REGIONAL SAFETY RECALLS 13V-547, 12V-306 AND 10V-436 BULLETIN UPDATE ANNOUNCEMENT

This letter and specific bulletin sections are being sent to you to notify you of bulletin updates for Safety Recalls 13V-547, 12V-306 and 10V-436 – Corrosion Affecting the Forward Mounting Point for Rear Suspension Lower Link Brackets on certain Isuzu passenger vehicles.

PROCEDURE INFORMATION UPDATE – ALL BULLETINS

INSPECTION (ALL VEHICLES)

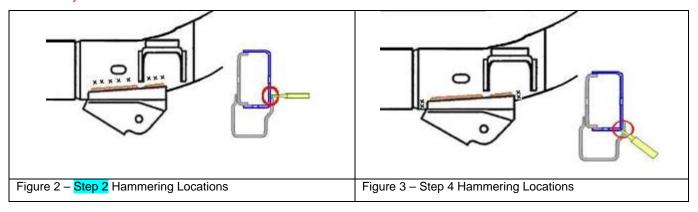
The inspection procedure in these bulletins has been updated to include the punch and hammer test for all vehicles. Additionally the "Claim Information" sections of each bulletin have been updated to reflect the increased labor allowance for this additional process. We have included a "Claim Information" summary with this notice as a reference for your service personnel.

- Raise the vehicle. When placing the lift points, be sure to keep the rear lifting points at least 300mm (12 inches) ahead of the rear lower trailing link front mounting bracket. This spacing is necessary for inspection and repair accessibility.

- 2. Using a 3/16" flat punch and a 12-16 oz. hammer, hammer on the locations identified with an "X" in Figure 2. Swing the hammer 10 to 12 inches to be sure enough force is applied to the punch. If a hole is created go to Step 4. If no hole is created, visually inspect the Rear Lower Trailing Link Front Mounting Bracket inspection area. Use the Visual Comparison Photo (P/N 2-90SVA-003-0) or Figure 1 for reference. If most of the frame coating is still in place and very little surface rust is present, apply Noxudol 300 (Go to "Condition One: Apply Noxudol 300" in this bulletin). If most frame coating is missing and excessive rust is present go to the next step.

- 3. Apply Noxudol 700 and Noxudol 300 (Go to "Condition Two: Apply Noxudol 700 and Noxudol 300" in the appropriate bulletin).
- 4. Using a 3/16" flat punch and a 12-16 oz. hammer, hammer on the locations identified with an "X" in Figure 3.
 - a. If no hole is created, continue to <u>Condition Three</u> in the appropriate bulletin.
 - b. If the flat punch creates a hole in any one location, continue to <u>Condition Four</u> in the appropriate bulletin.
